SERVICE INFORMATION LETTER

SERVICE INFORMATION LETTER INDEX

FIGURE 1

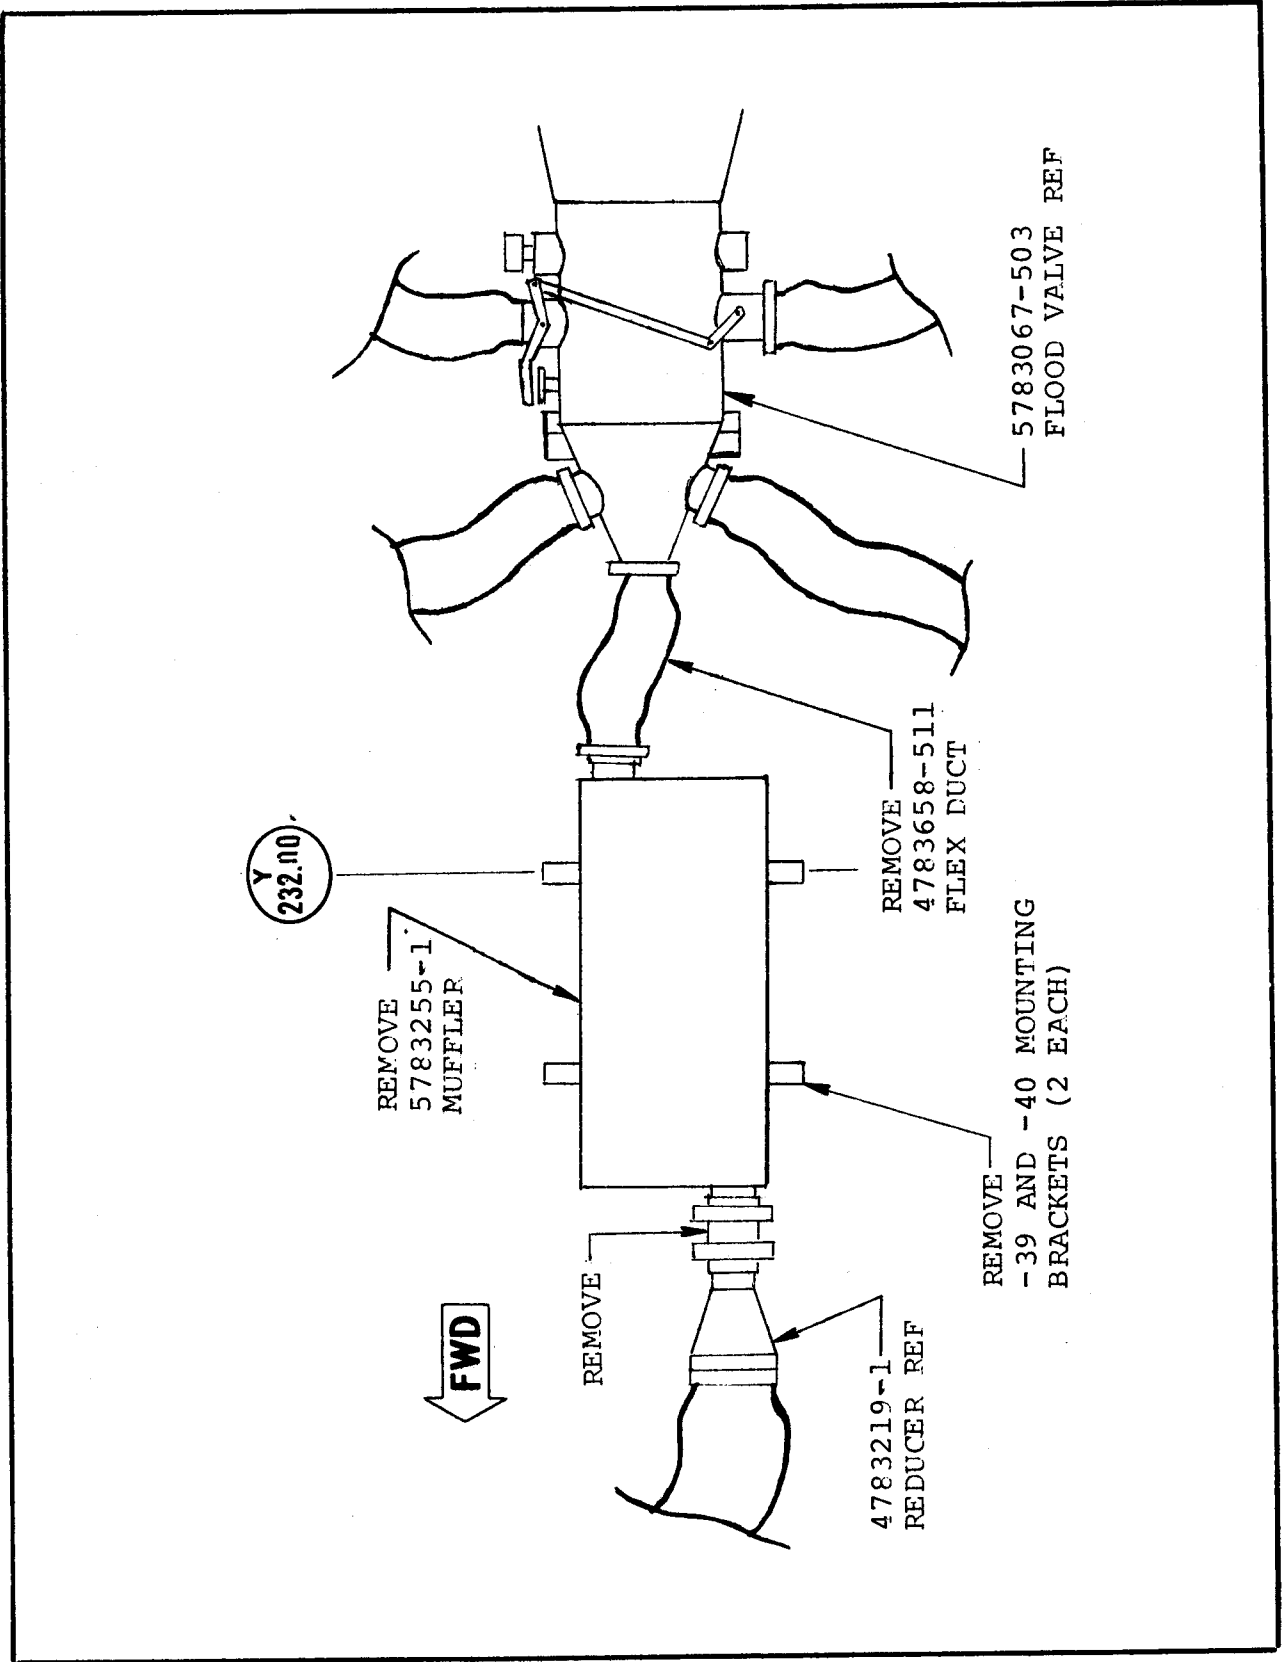
1. Gain access to air-condition muffler under the floor in rear cabin area.
2. Remove floor as required to enable work.
3. Disconnect and remove Muffler P/N 5783255-1, Flex Duct P/N 4783658-511, coupling duct, and Clamps P/N U84-210SH. Drill out rivets of -39 and -40 muffler mounting brackets; remove brackets. (SEE FIGURE 1)
4. Install Flex Duct P/N 4783658-523 between Reducer P/N 4783219-1 and Flood Valve P/N 5783067-503, using 2 each Clamps P/N U84-210SH originally removed (SEE FIGURE 2).
5. Relocate one -40 bracket to provide support for Flex Duct P/N 4783658-523, and secure with NAS1398D4-2 rivets. Install Clamp P/N MS21919DG35; locate and drill .190 dia. hole in -40 bracket for proper alignment of Flex Duct. Secure Clamp to bracket with AN3C4 Bolt, AN960-10L Washers (2 required), and MS20365-1032 Nut. (SEE FIGURE 2)
6. Close up floor and reinstall interior.

FIGURE 2

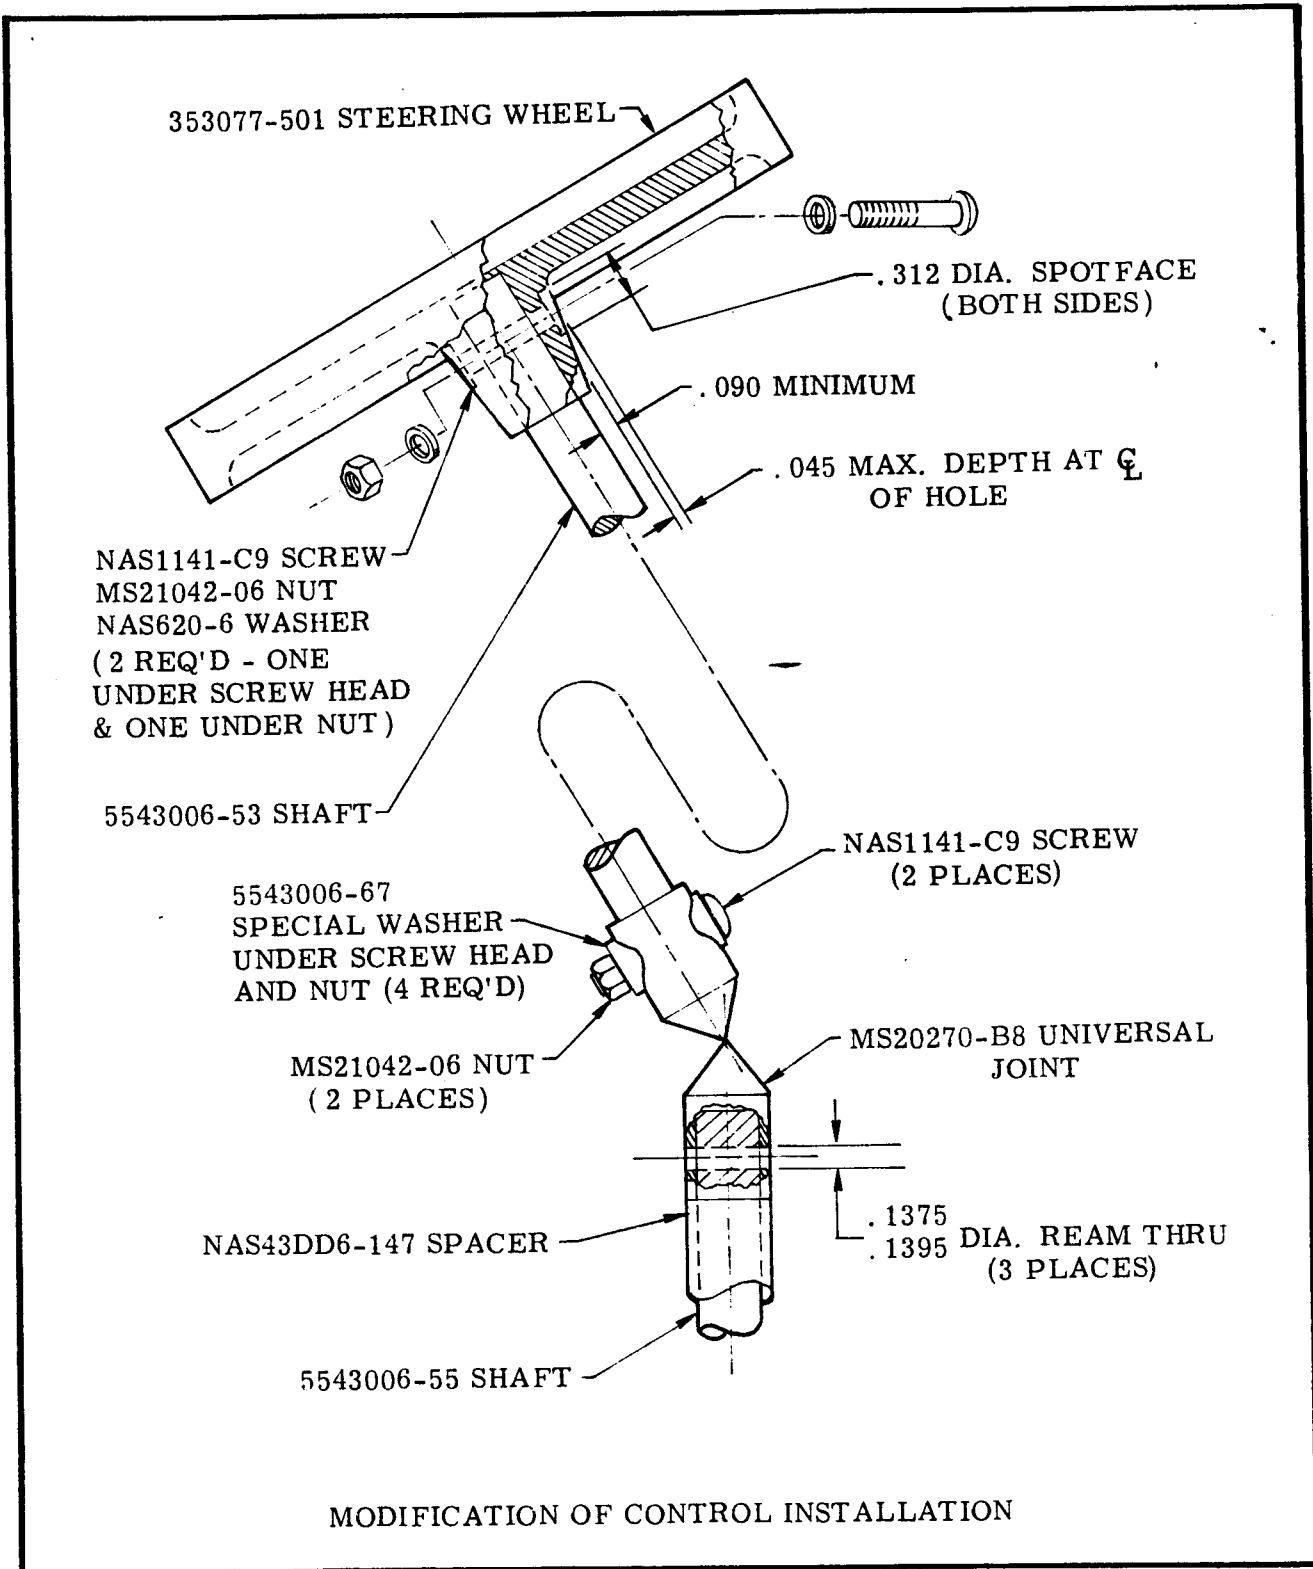
4. Install NAS 1141-C9 screw, two 5543006-67 special washers, and MS21042-06 nut, NAS 620-6 washers at both locations on universal joint. (SEE FIGURE 2)

5. Enlarge existing fastener holes in 3530077-501 steering wheel with .1375 dia. reamer. Spot face hub as shown (maintain .090 minimum thickness). (SEE FIGURE 2)

FIGURE 2

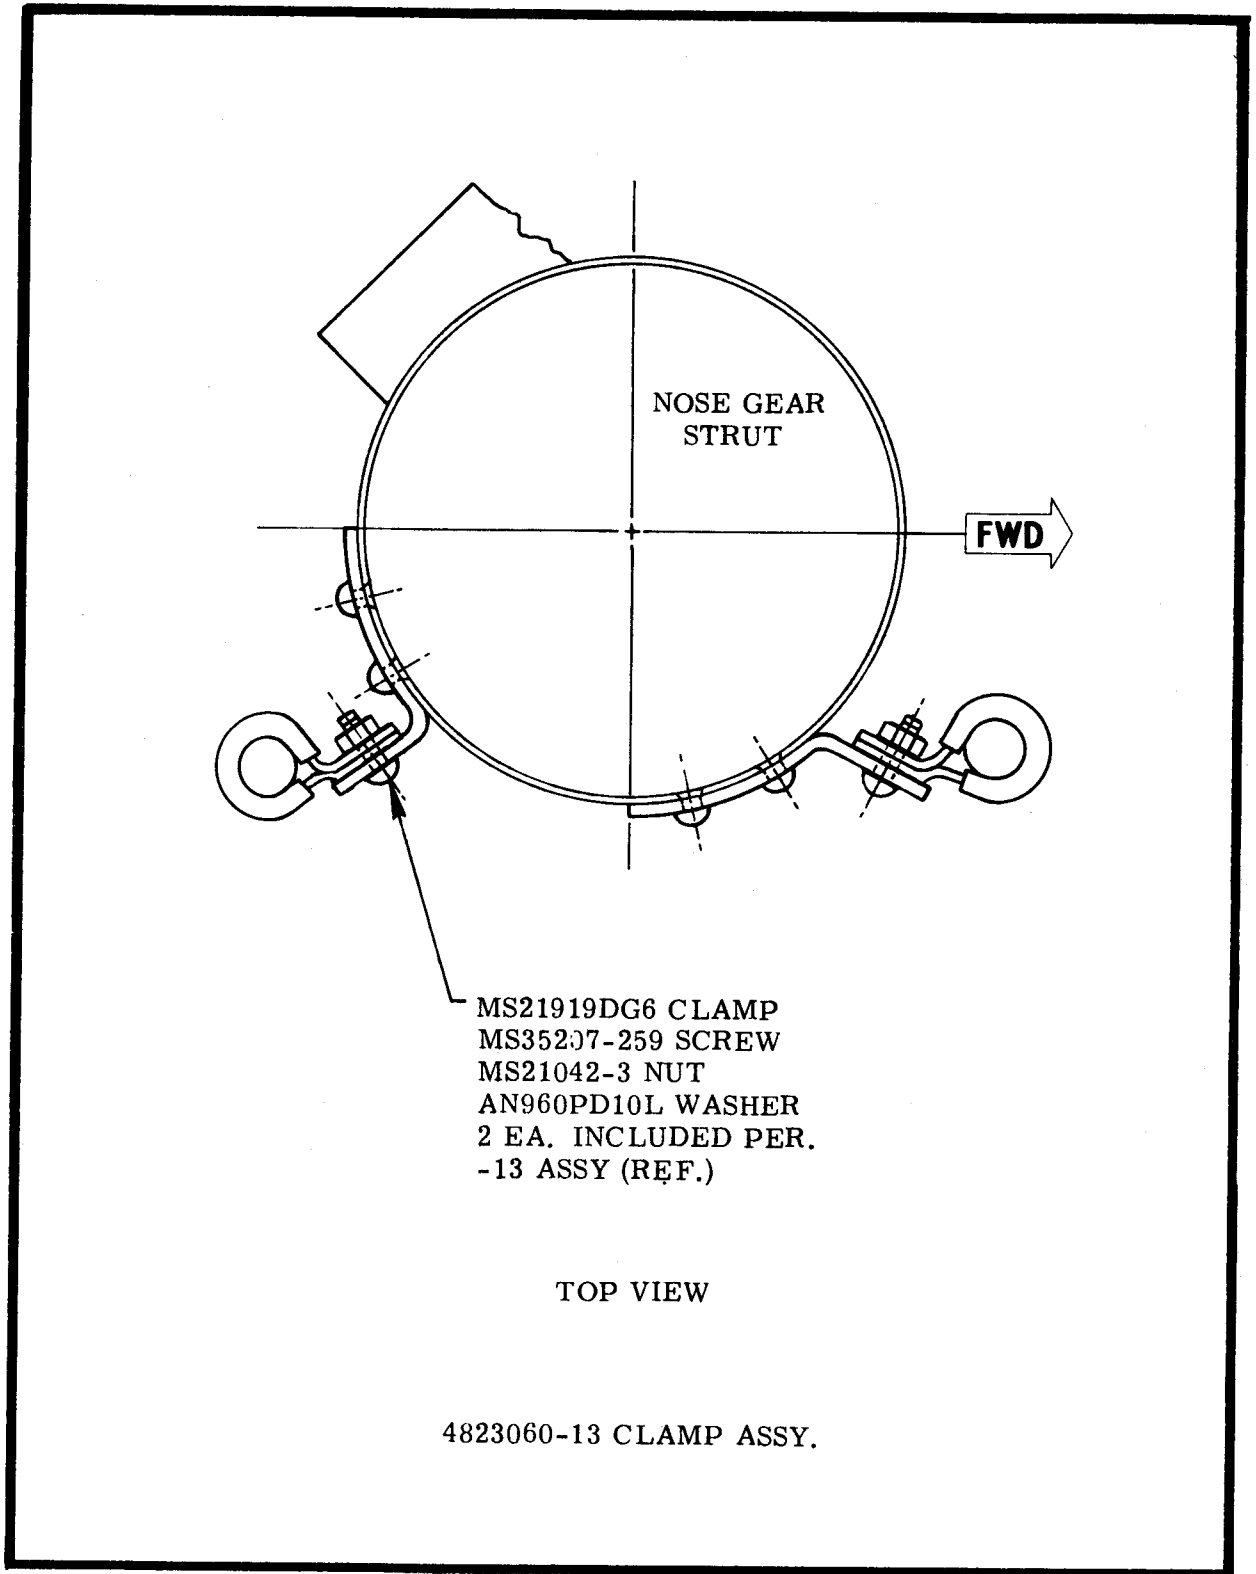
3. Install new MS25281-R8 wire bundle support clamp to 4823060-3 plate, using hardware provided, per Figure 1. Install new P/N 4823060-13 clamp assembly on nose gear strut body as per Figure 2. Check wire bundle for proper routing and freedom from stress between support clamps when nose gear is rotated to full deflection in left and right turns.

FIGURE 1

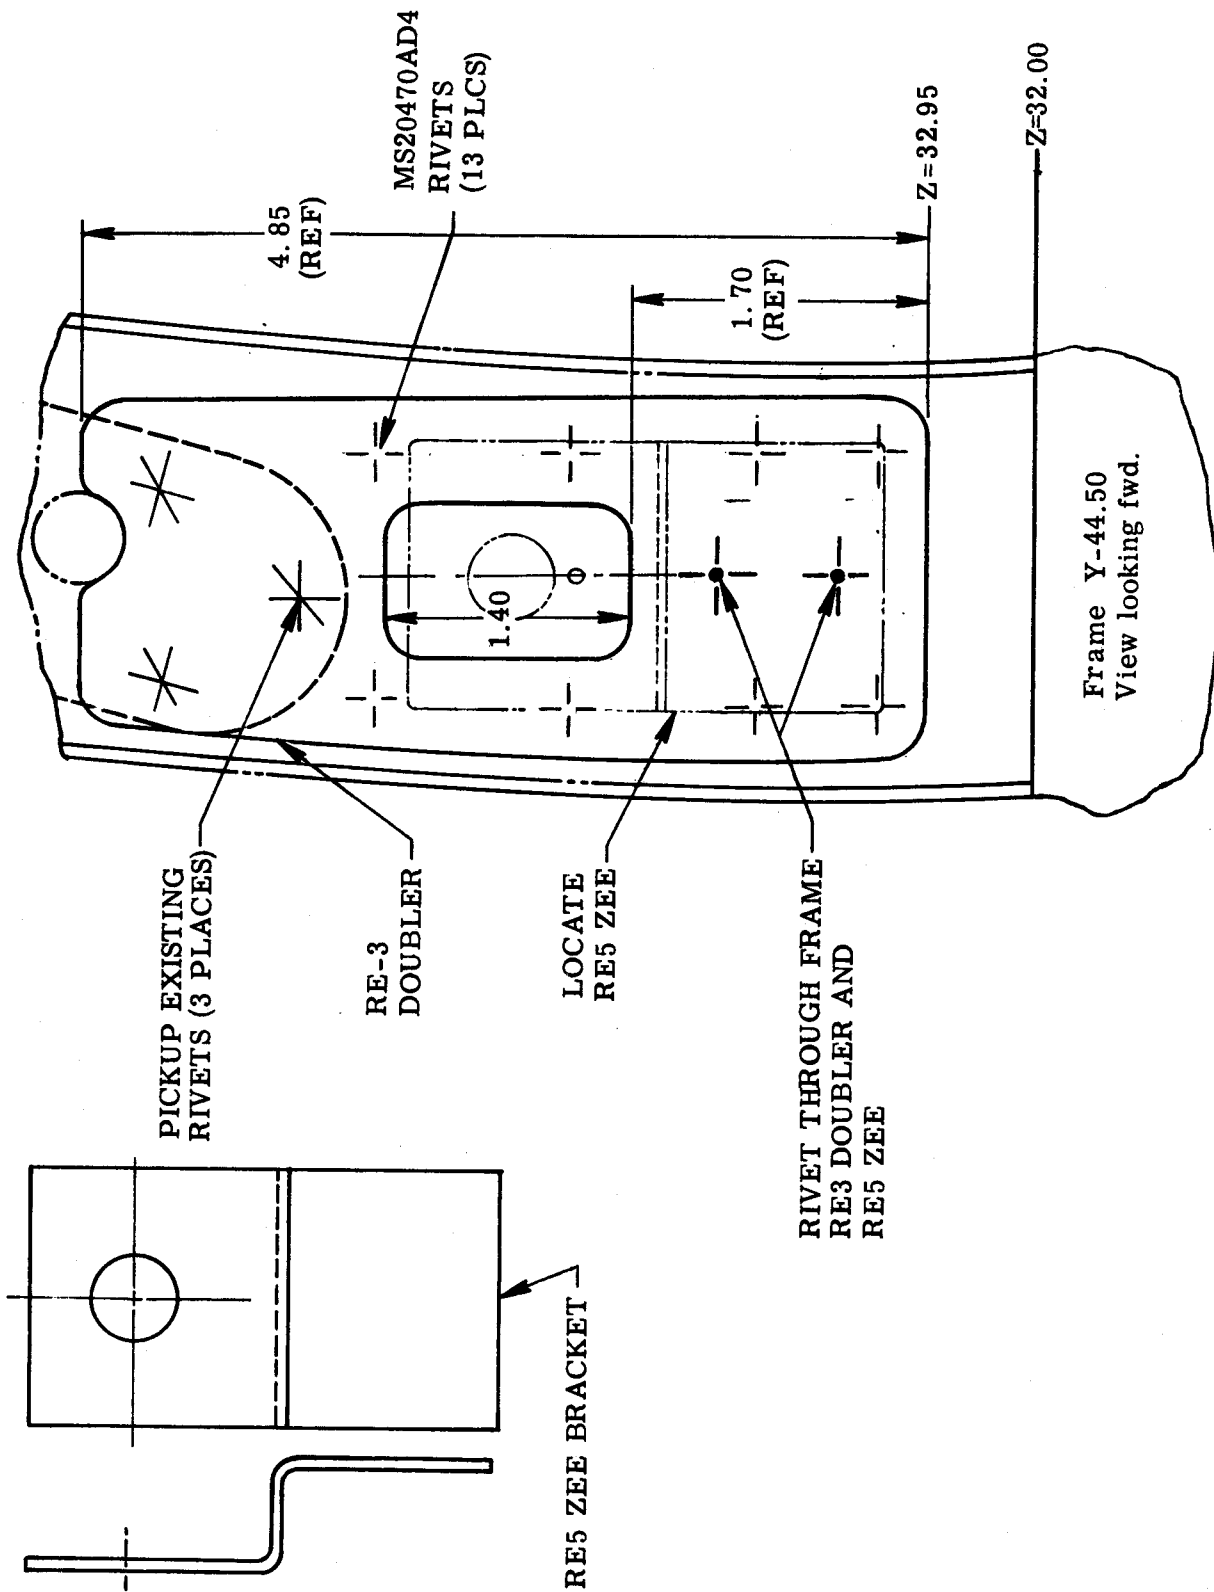
6. Install RE3 doubler and RE5 zee bracket on Fus. Sta. 44.50 frame in accordance with Figure 1.
7. Temporarily replace pilots side panel to permit locating and marking position for RE7 placard installation. Mark center of hole to be drilled to accommodate nose steering sensitivity switch installation.

9. Install the 1TL1-2 switch in the RE5 zee bracket that was previously installed (See Figure 1).
10. Drop overhead circuit breaker panel and remove and discard existing 3 amp. nose steering circuit breaker. Install new 5 amp. nose steering circuit breaker and secure circuit breaker panel.

FIGURE 2

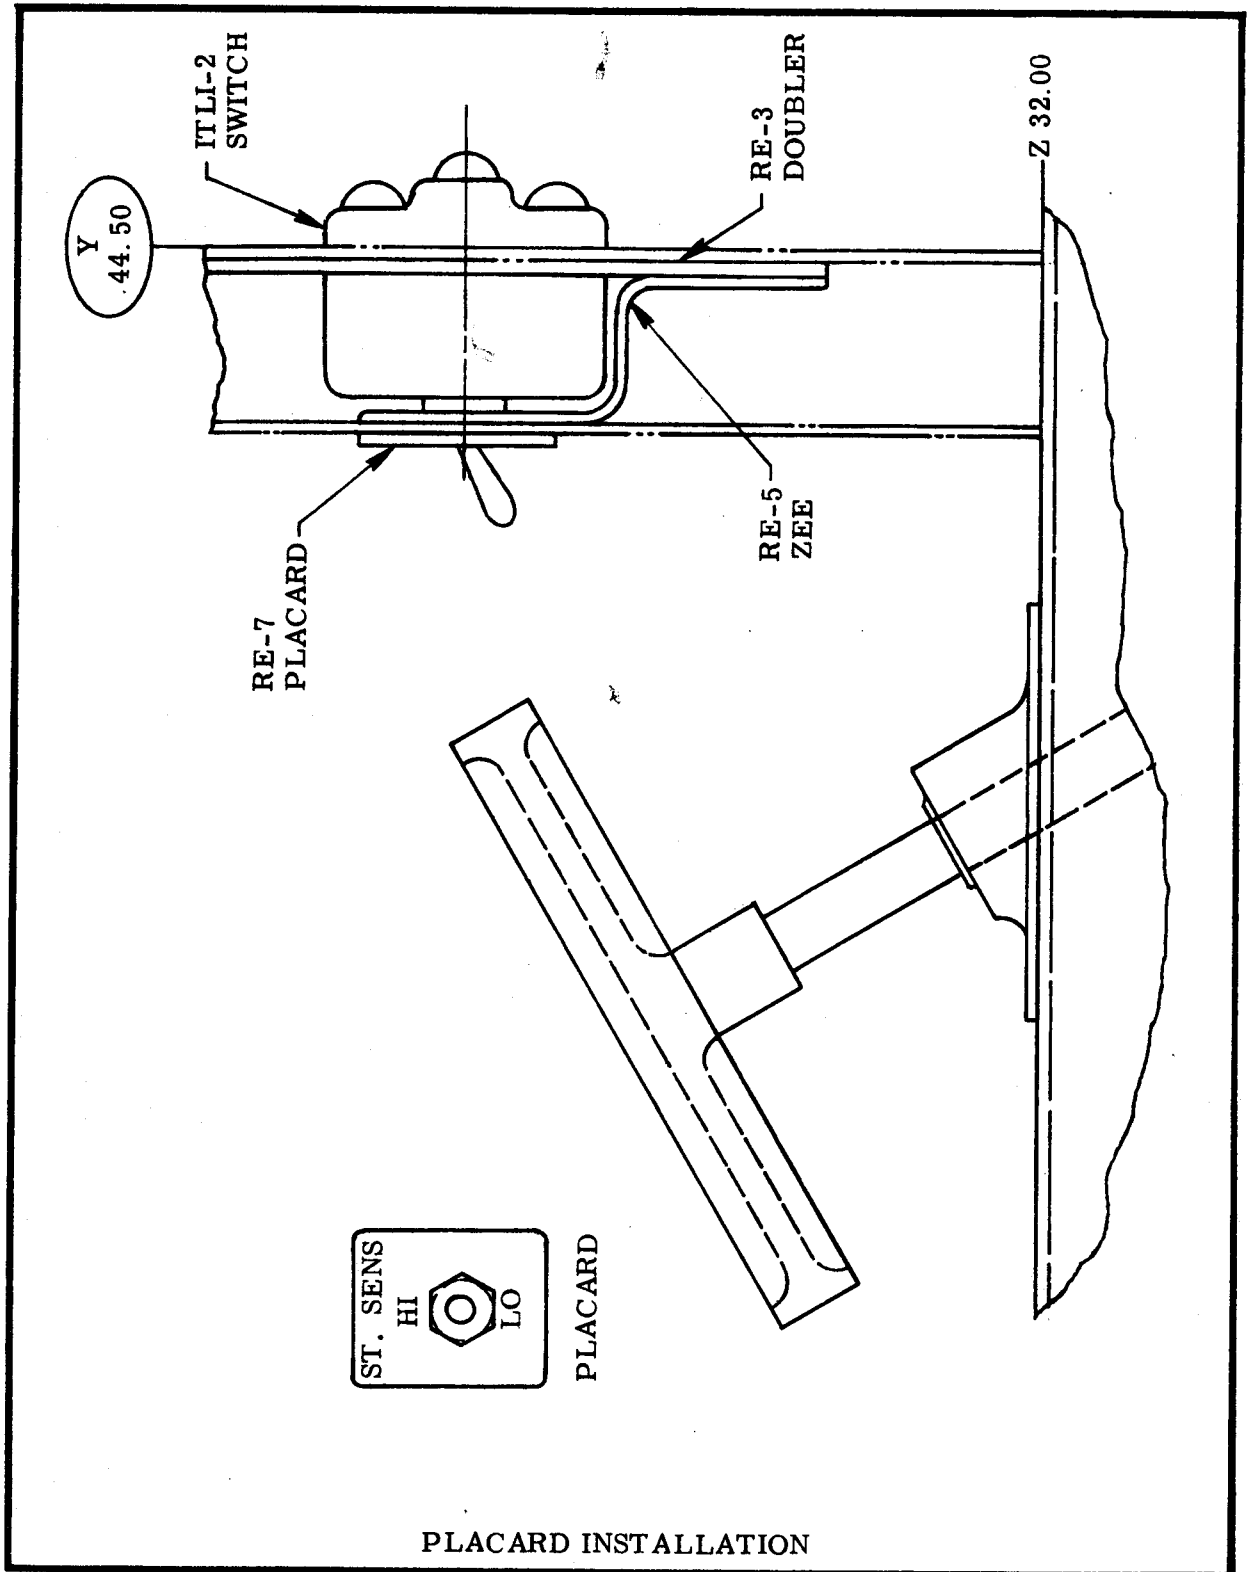
8. Remove side panel and drill 0.50 dia. hole through pilots side panel as marked. Bond the RE7 placard in place, using EC1403 cement or equivalent, as per Figure 2.
